**MEHL Integrated Waste
Management Facility**

EPA Waste Licence Application
W0129-03. Response to EPA Article
16: Groundwater

Issue 1 | 16 October 2013

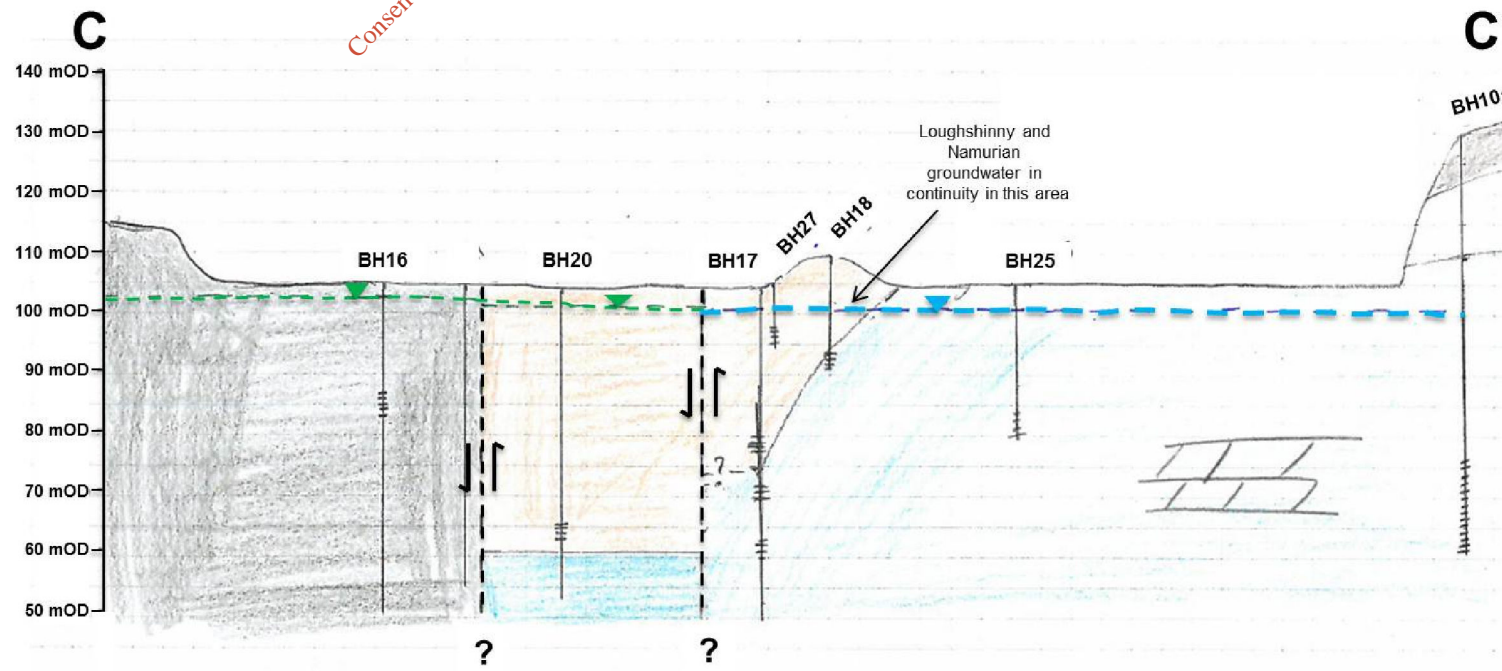
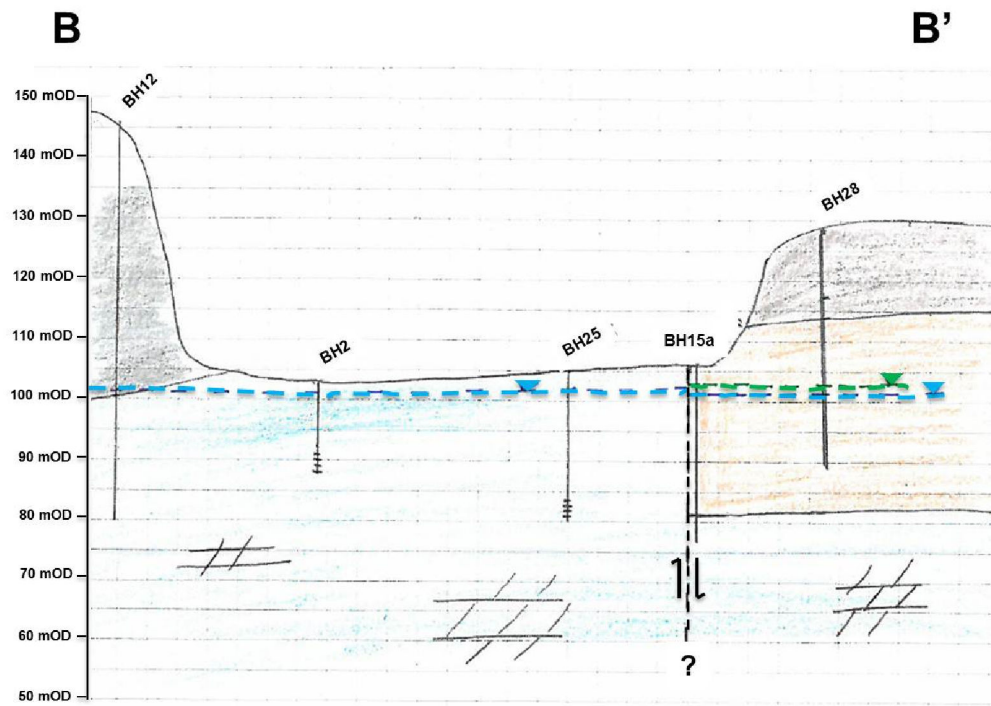
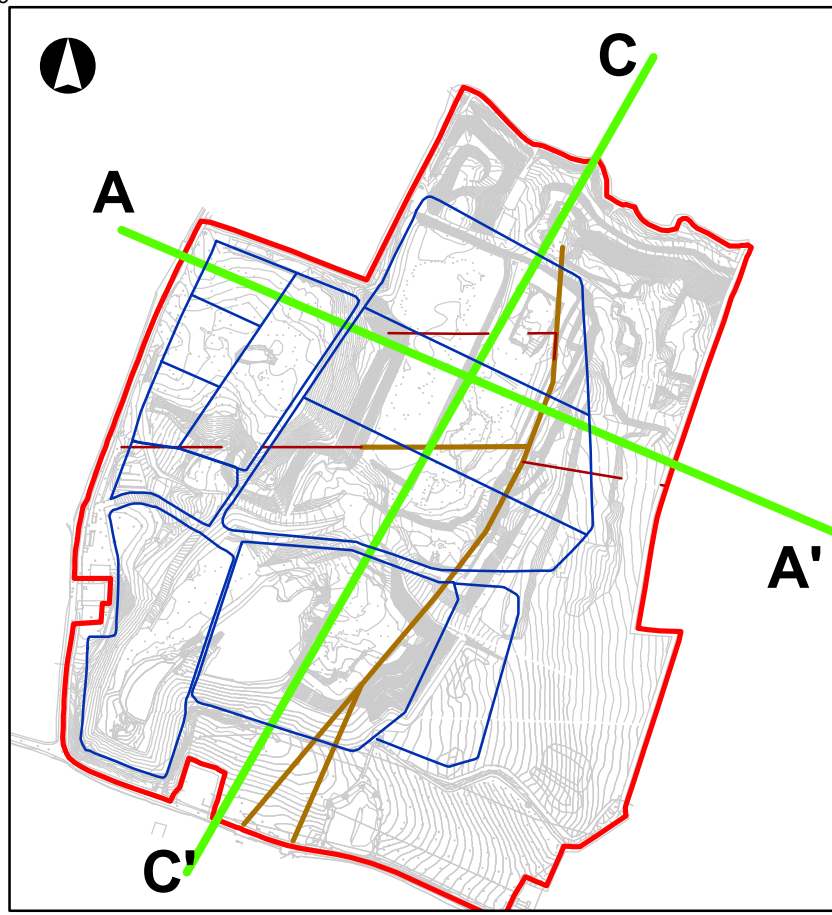
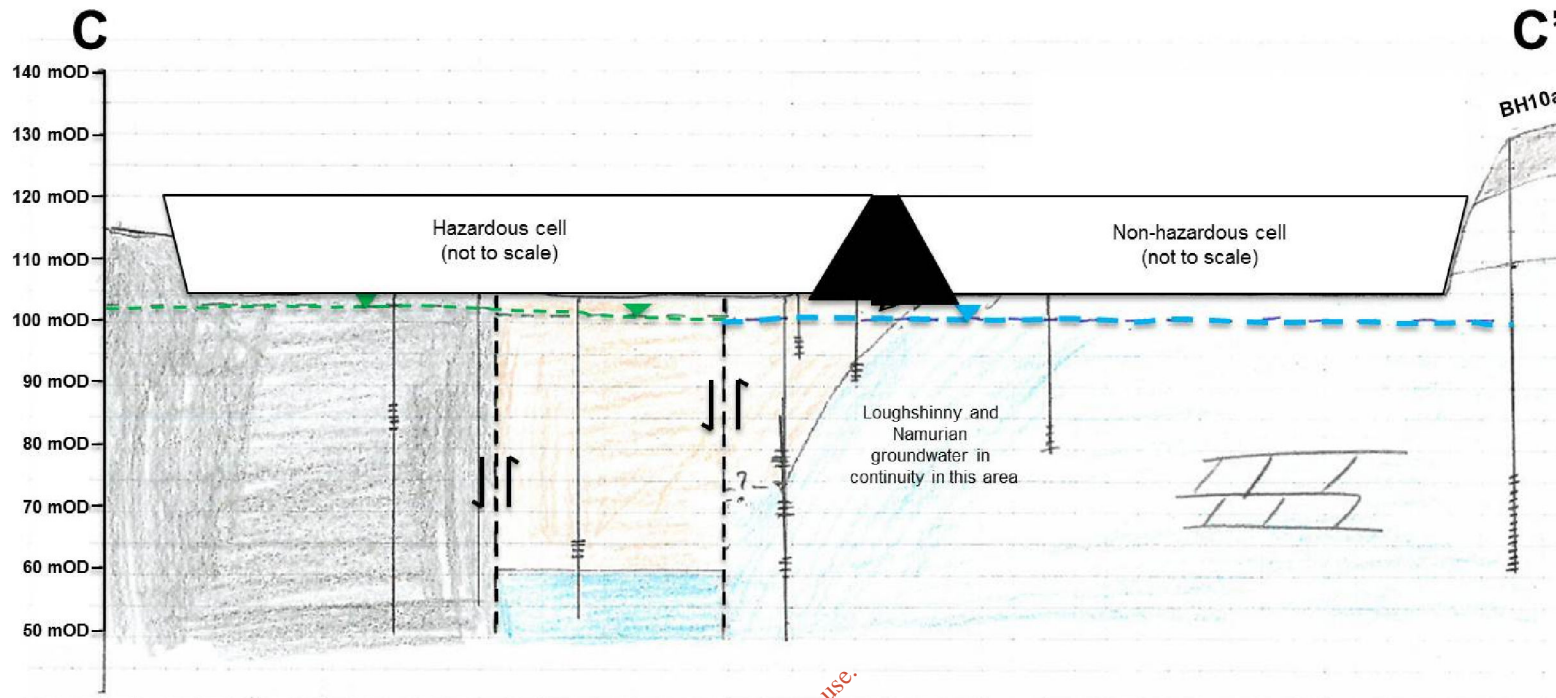
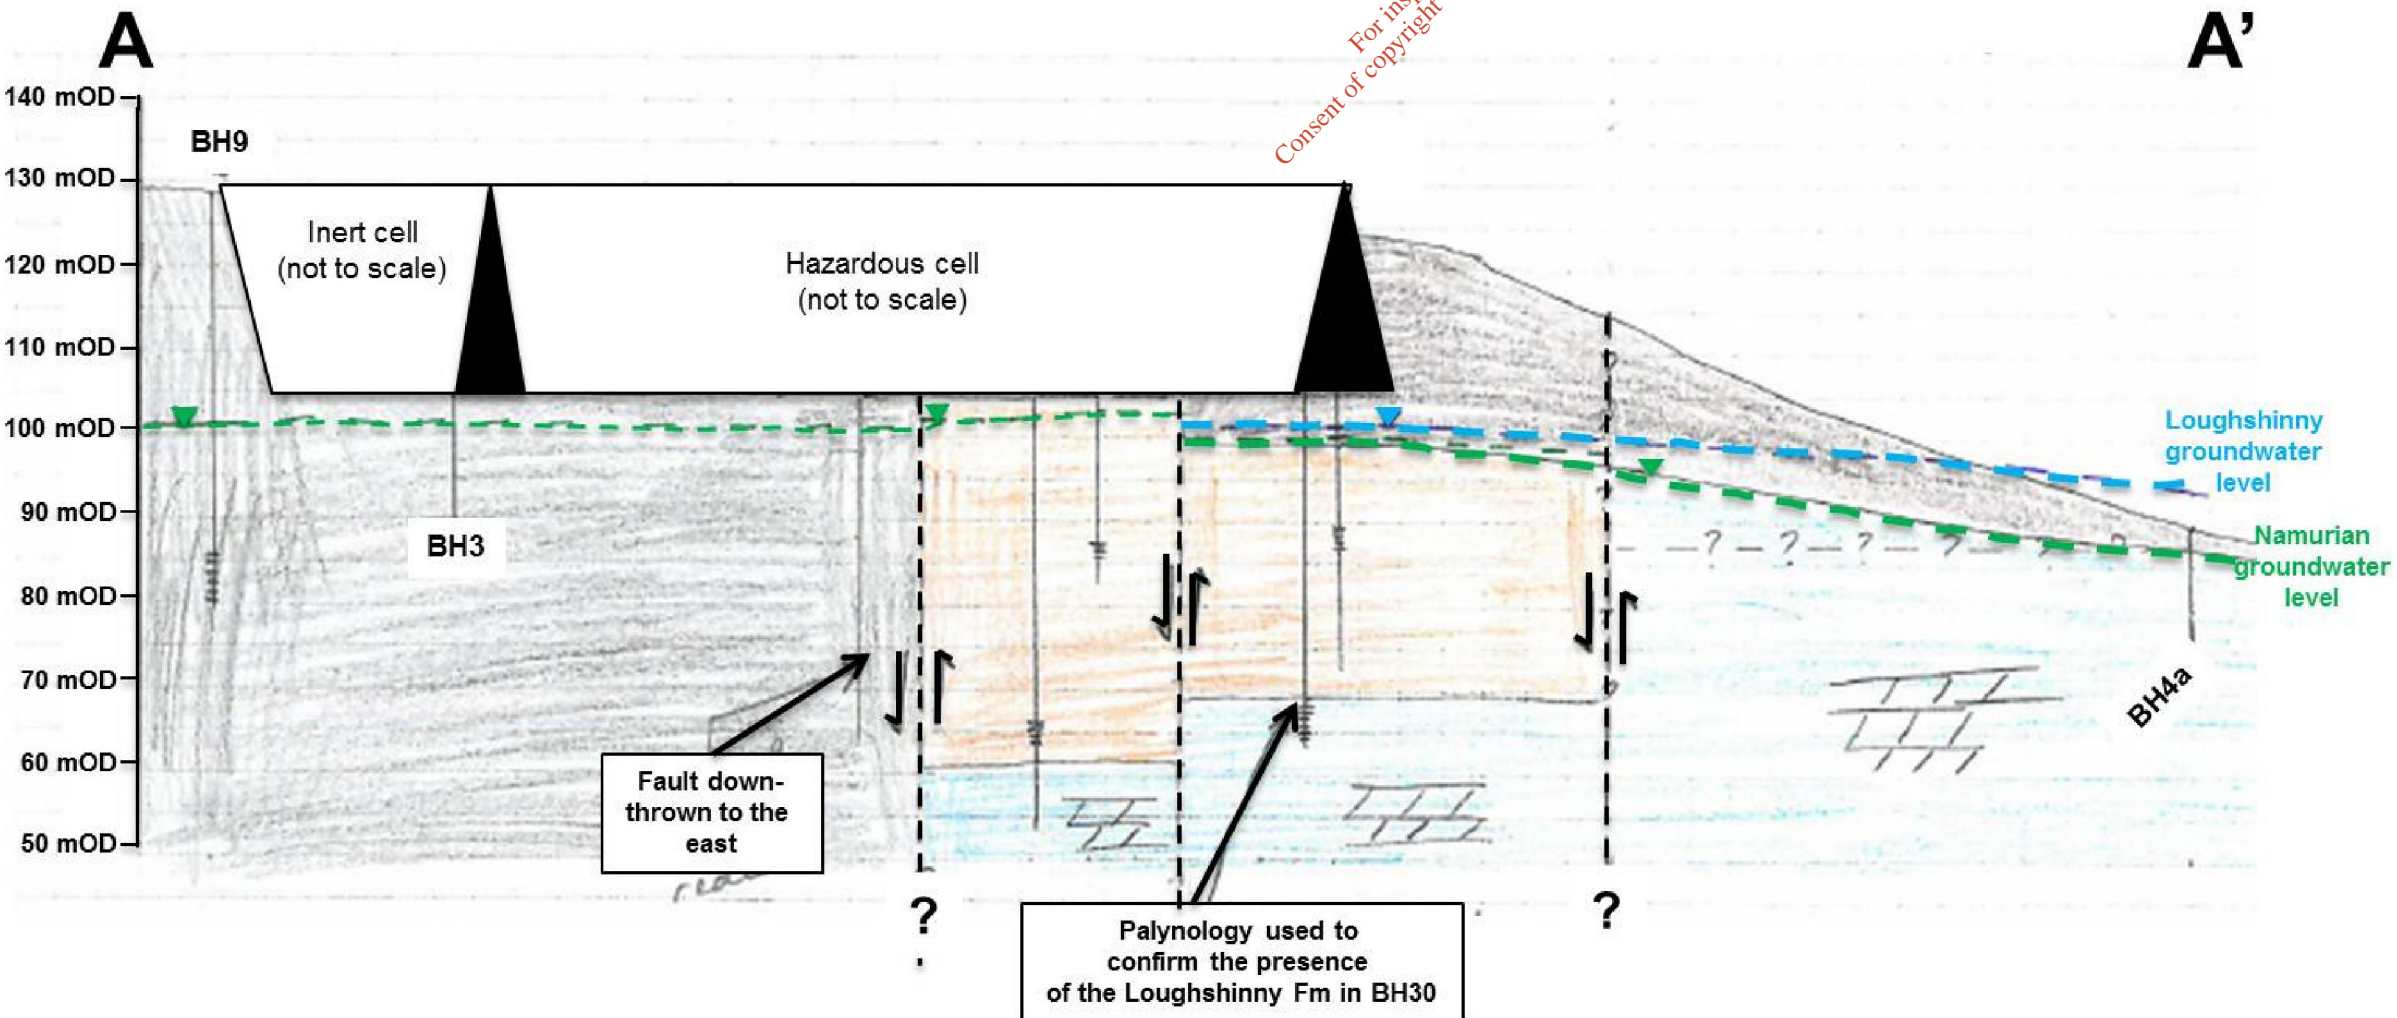
d) A series of cross-sections (e.g. one N-S through the proposed waste cells, and two E-W through the proposed waste cells) that accurately show the geology derived from borehole logs and head gradients derived from monitored water levels in boreholes screened in different strata;

A conceptual site model presenting the proposed development, superimposed on the above cross-sections, is shown in **Figure 8**. Please note the design details of the landfill construction have been generalised on the diagram to illustrate their overall geometry e.g. the individual hazardous cells have not been represented, they have been presented as a single hazardous cell.

**Figure 9.
 Proposed groundwater monitoring
 locations**

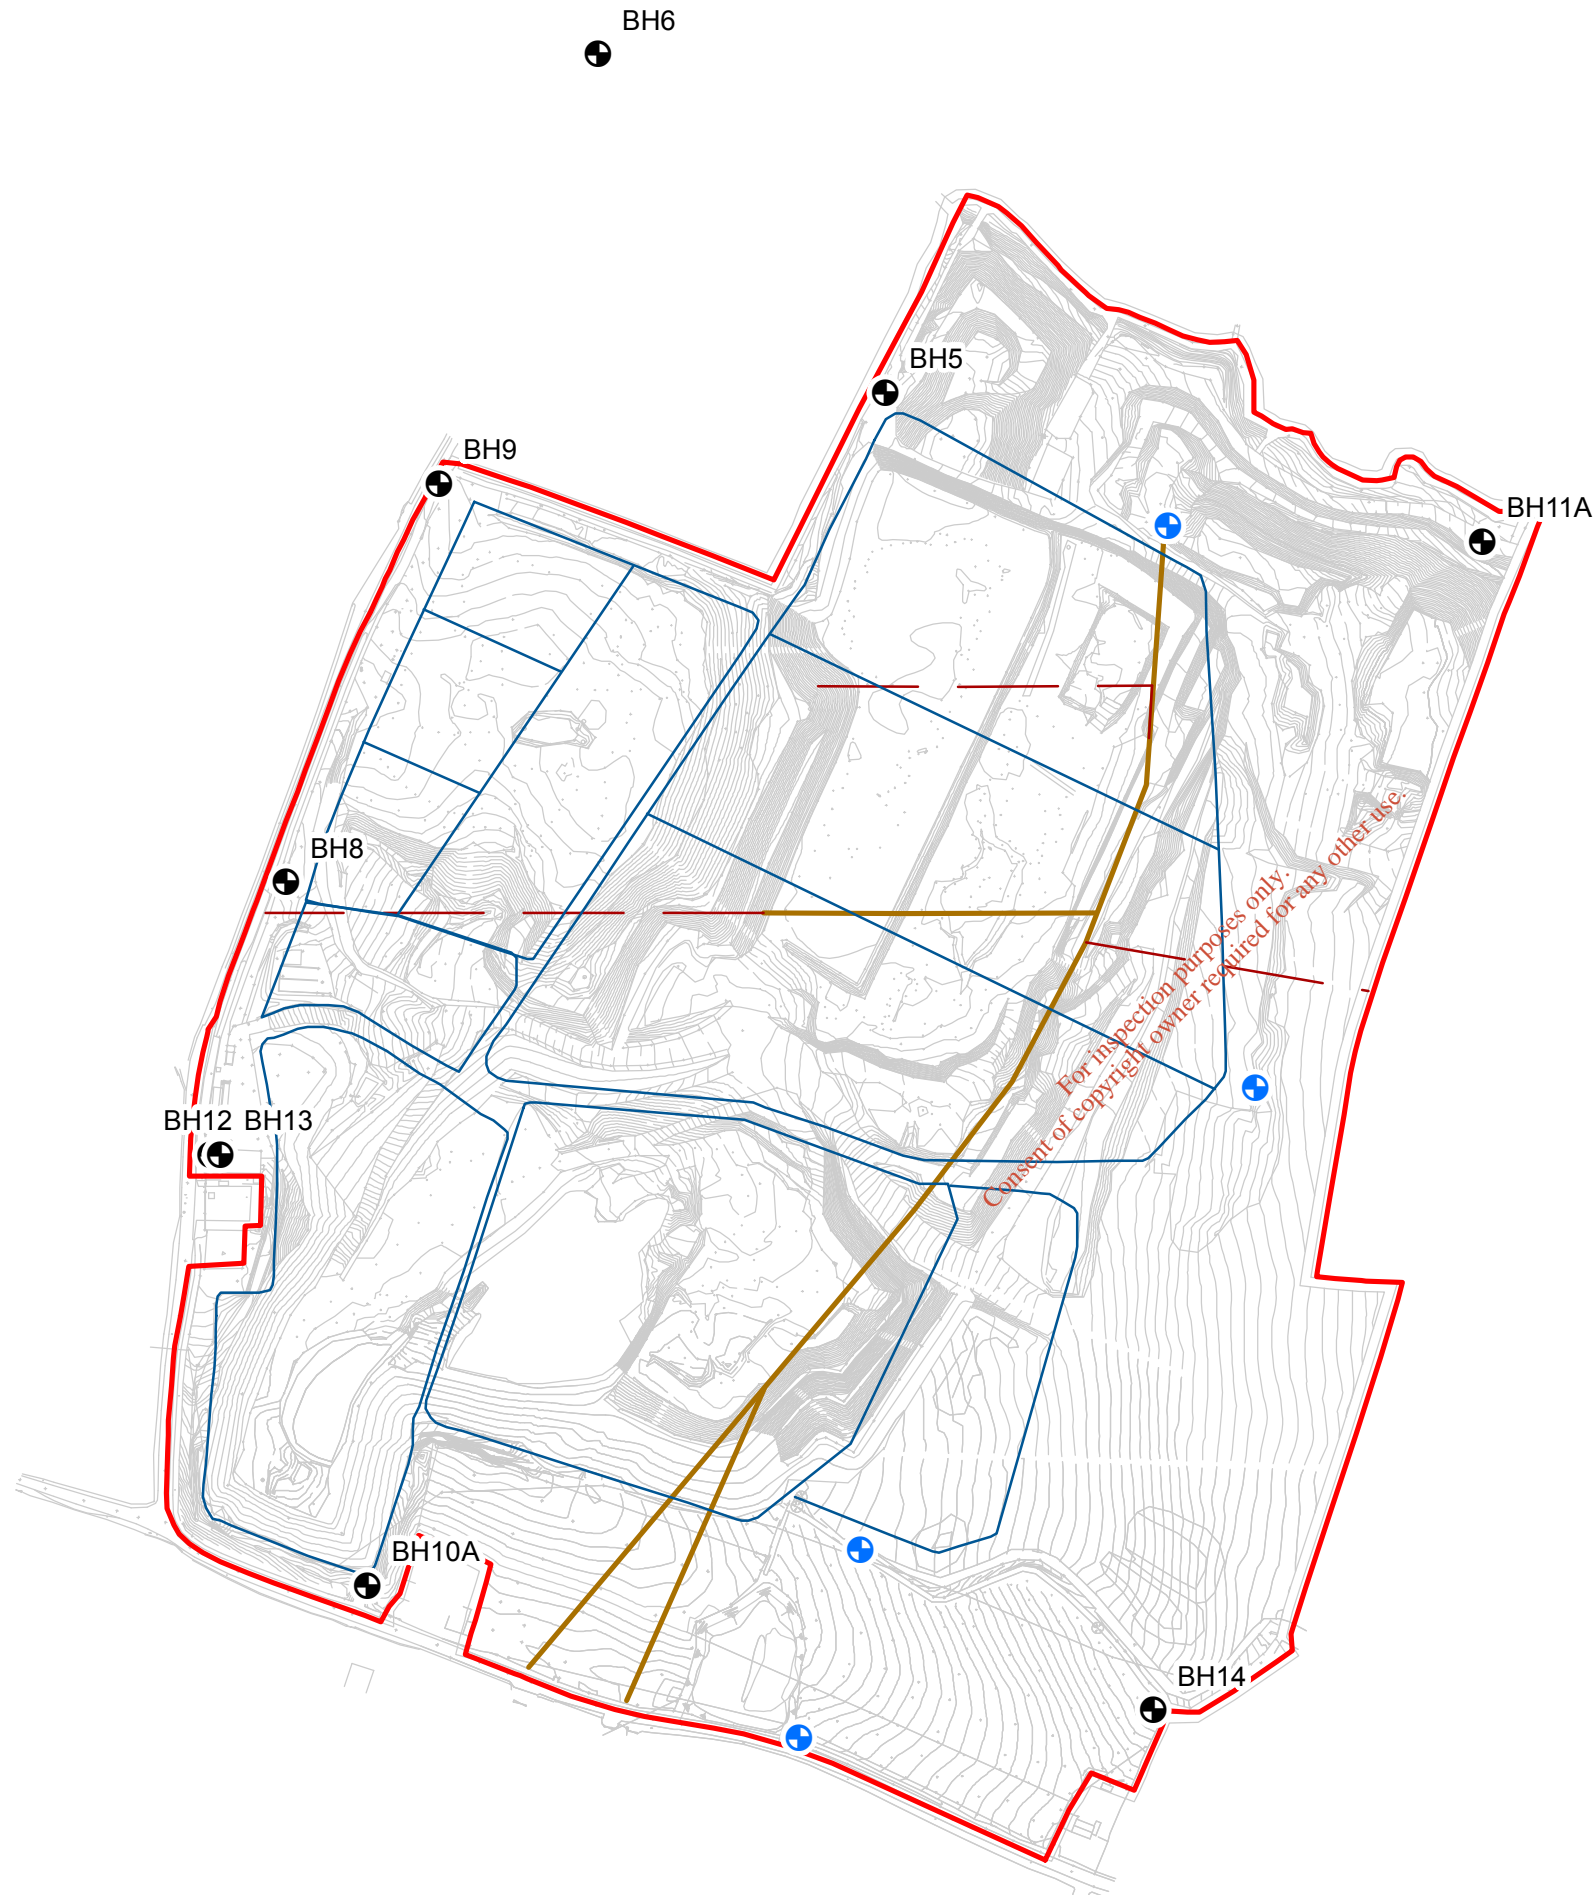
3.2 *In accordance with the requirements of the European Communities Environmental Objectives (Groundwater) Regulations 2010 and having regard to Guidance on the Authorisation of Discharges to Groundwater, published by the Environmental Protection Agency, provide a technical assessment in relation to the setting of groundwater compliance points and values. Propose the compliance points to be utilised, the corresponding compliance values and the compliance monitoring to be employed.*

The proposed compliance monitoring network is shown on **Figure 9**. In accordance with the EPA publication *Guidance on the Authorisation of Discharges to Groundwater* the monitoring network points have been based on the conceptual model for the site:

- The monitoring points have been placed in an outer and inner ring to allow any breaches of trigger levels to be detected before they reach the site boundary. The compliance points are those marked on **Figure 9**.
- All wells will have response zones in both the Namurian strata and the Loughshinny.
- Existing wells on site will be incorporated into the monitoring network, particularly for the up-gradient wells. New down-gradient wells will be installed in the direction of flow (south east) and also the north and east.
- Monitoring wells will be located in known fault zones to ensure that any potential movement of contamination is detected

The locations shown on **Figure 9** are indicative only and the exact locations will be agreed in consultation with the Agency, and with due regard for site conditions, the location of site infrastructure, access to monitoring locations etc. However, any monitoring point that is moved will comply with the requirements listed above.
